### **3. Right-of-Way Vacation; KPB File 2022-023VR1**

**Vacate a portion of Paper Birch Lane, a 60' right-of-way & associated utility easement**

**KPB 2022-023VR1**

**TULCHINA POINTE ESTATES 2022 REPLAT**

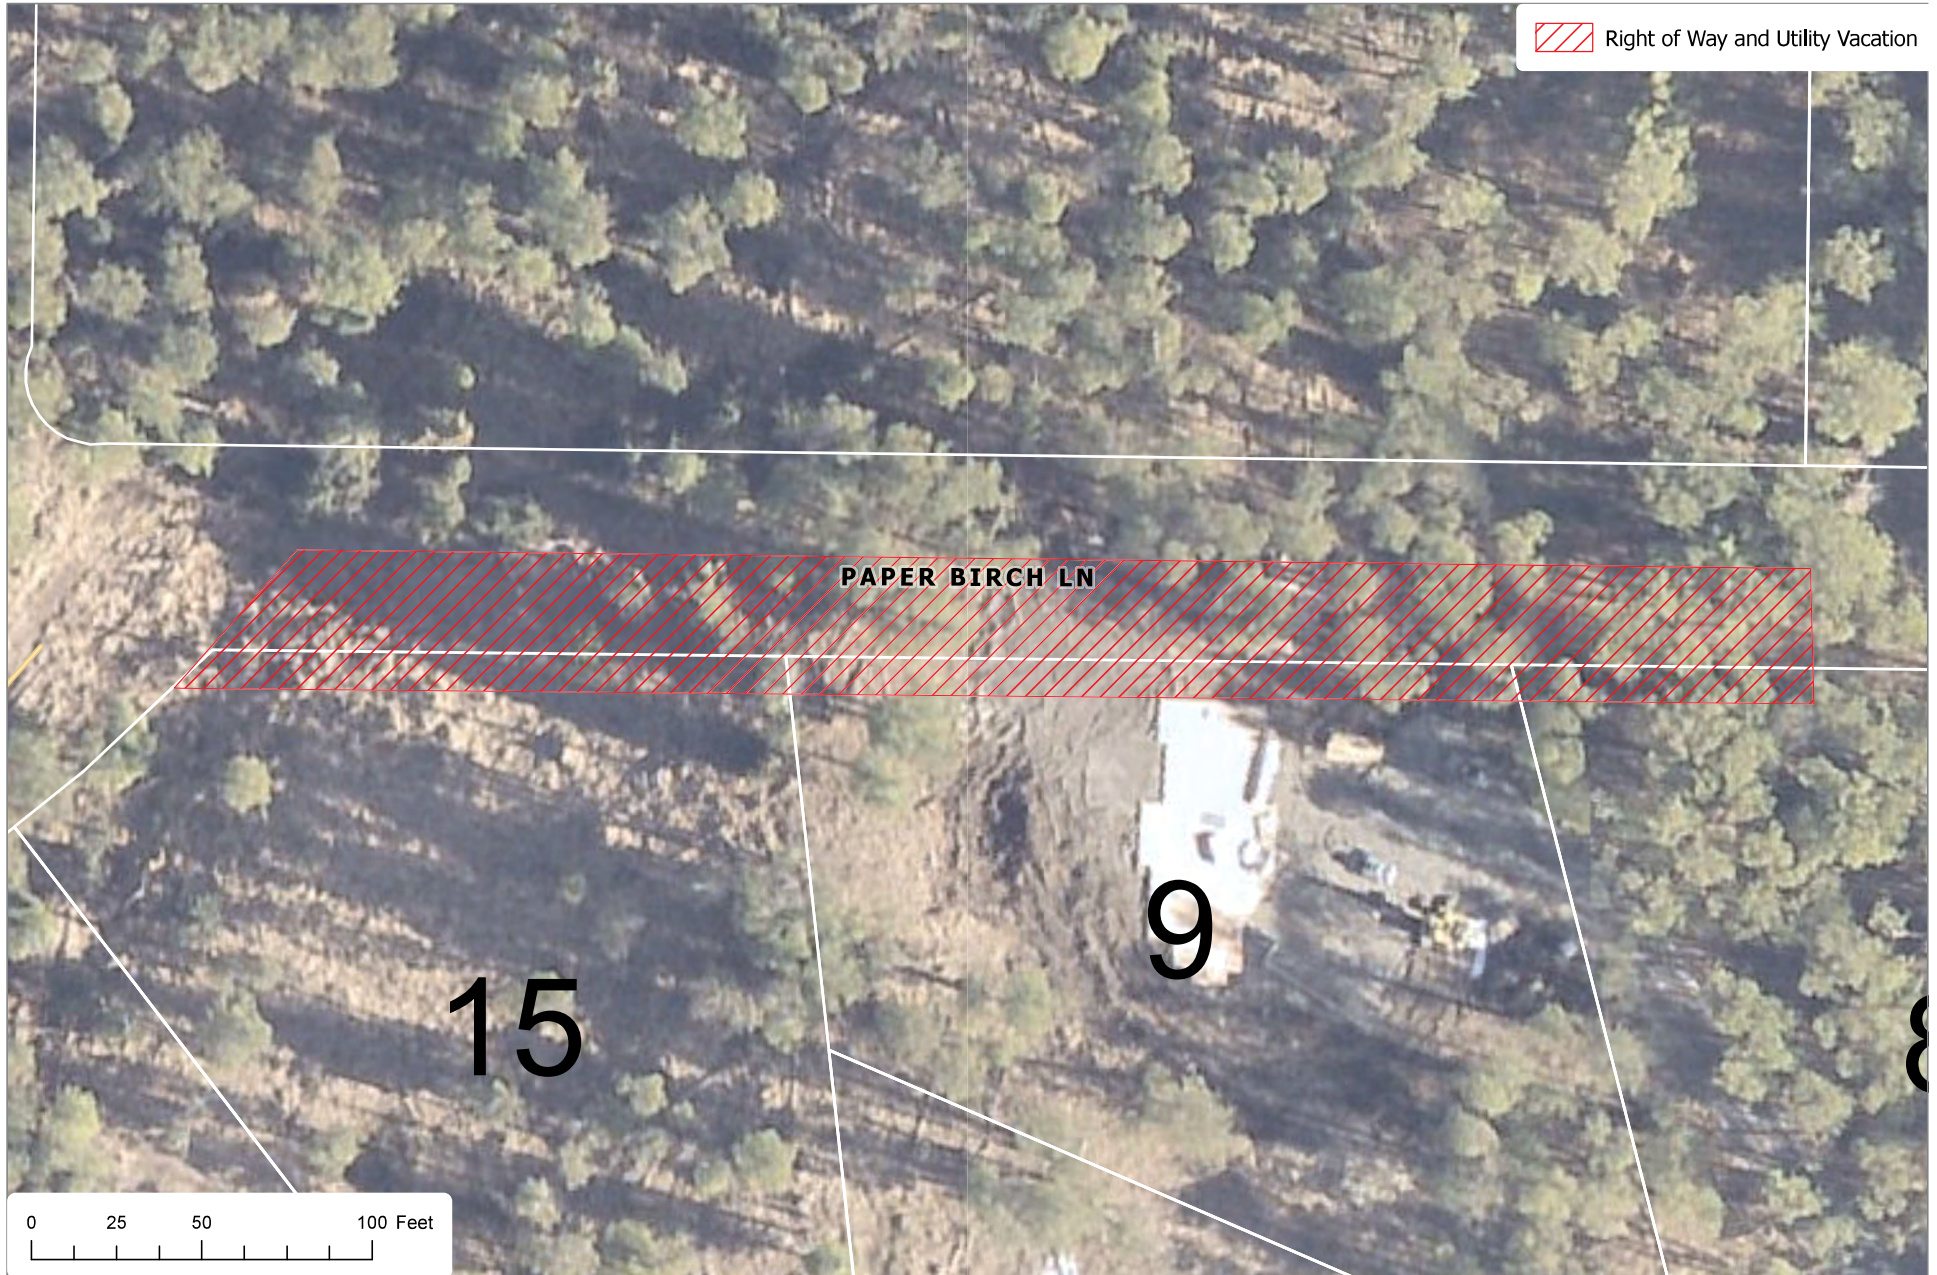
The owner of Lots 8 and 9 is LittleKnife Inc. The owner is a construction company that recently built a home on the lots for a client. It was determined that the house was constructed partially within the right-of-way. The as-built shows the house at a slight angle and around a 35 foot length of the house is within the right-of-way. The widest width of the encroachment appears to be approximately 9.6 feet. The well is also 13.7 feet into the right-of-way.

A bulb is proposed for a turnaround area. The 50 foot radius bulb will be dedicated from Lot 8 and will provide an adequate turnaround area that should not require additional dedications in the future.

The 30 foot wide portion of Paper Birch Lane proposed to remain will not provide a compliant right-of-way width. If the vacation is approved as shown, an exception to KPB 20.30.120 – Streets-width requirements will be required. Staff notes that the remaining portion of Paper Birch Lane will not comply with KPB 20.30.090 – Streets-Maximum grades allowed. Due to the terrain and the reduced width Paper Birch Lane will not be able to be a borough maintained right-of-way according to KPB Code requirements. The right-of-way will be able to be used by the public for all allowable uses.

The petition is proposing to vacate the associated utility easements along the portion of Paper Birch Lane to be vacated. New 10 foot utility easements will be placed along the newly dedicated bulb and along the southern boundary of the remaining 30 foot wide right-of-way. 10 foot utility easements will also be required to remain adjacent to Authentic Road and along the eastern property line adjacent to Paper Birch Land. A twenty foot setback will also be put into place along the southern boundary of the remaining 30 foot wide right-of-way.

Per KPB Code 20.90.100, Definitions, a well casing is allowable within the 20 foot setback as it does not impact the sight distance along the right-of-way. The well will not be within the new utility easement. A plat note will be requested to address the existing well.

Based on consideration of the merits as per KPB 20.65.050(D) as outlined by Staff comments, Staff recommends APPROVAL as petitioned, subject to:

1. Consent by KPB Assembly.
2. Compliance with the requirements for preliminary plats per Chapter 20 of the KPB Code.
3. Grant utility easements requested by the utility providers.
4. Submittal of a final plat within a timeframe such that the plat can be recorded within one year of vacation consent (KPB 20.70.130).

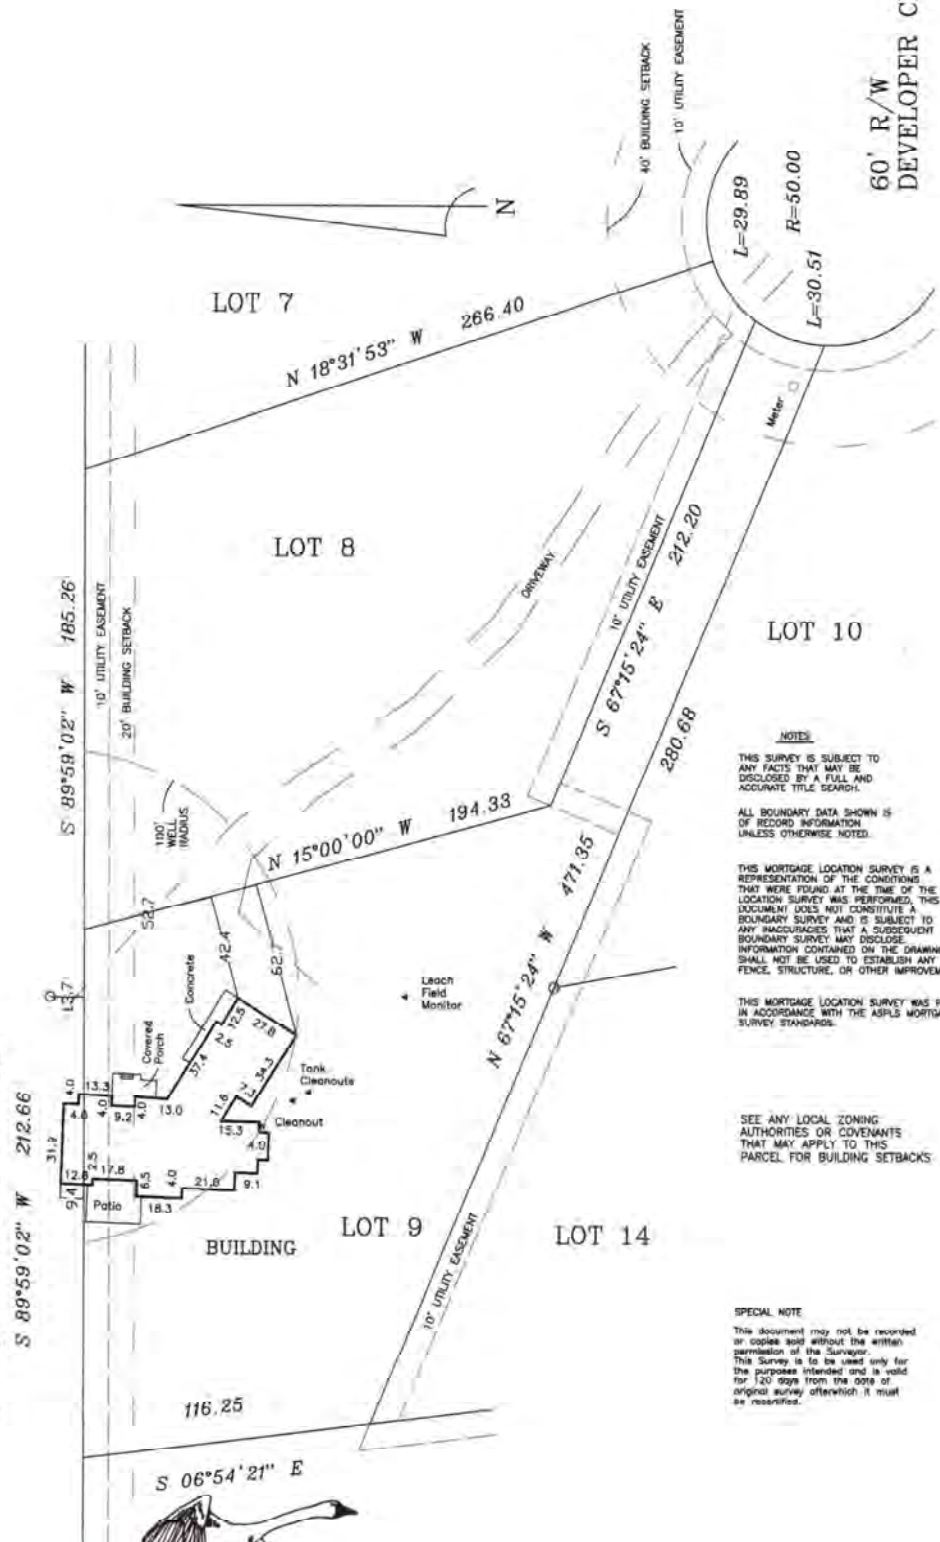
**Staff comments:** There is a structure within the right-of-way.

Approved R/W  
around steep  
terrain being  
dedicated per KPB  
File No. 2019-117

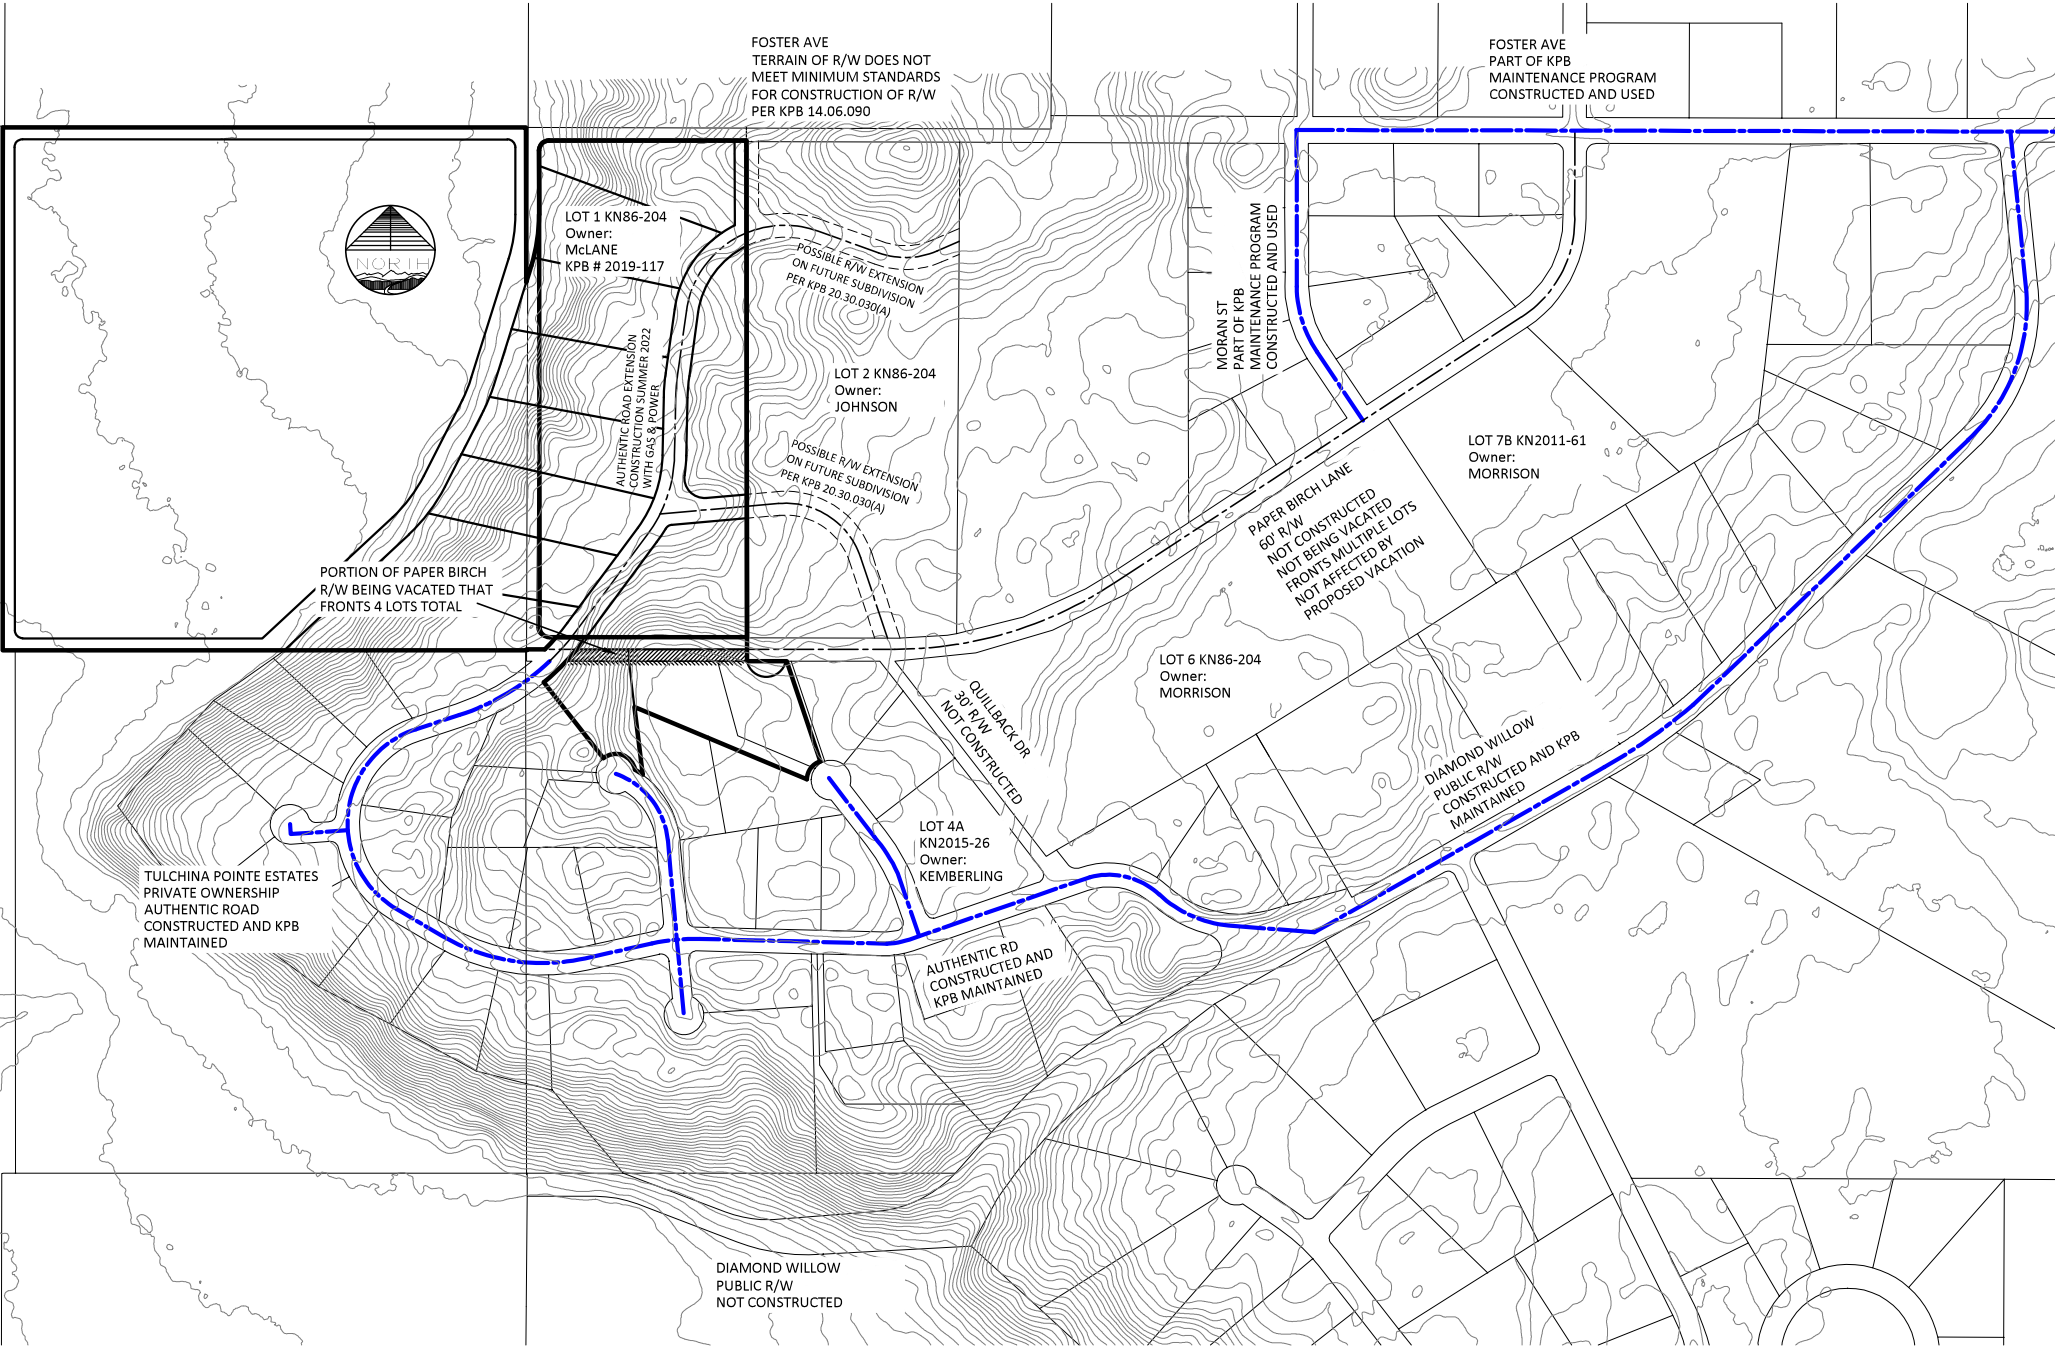
Paper Birch Lane, Quillback Drive, and Authentic Road provide a closed block. The length around Authentic Road is not compliant. Multiple rights-of-way are off Authentic Road but they are cul-de-sacs and do not improve the block. The reason for the placement for the new rights-of-way in the proposed subdivision to the north is due to terrain. The sketch provided shows the steep terrain within the Paper Birch Lane Dedication.
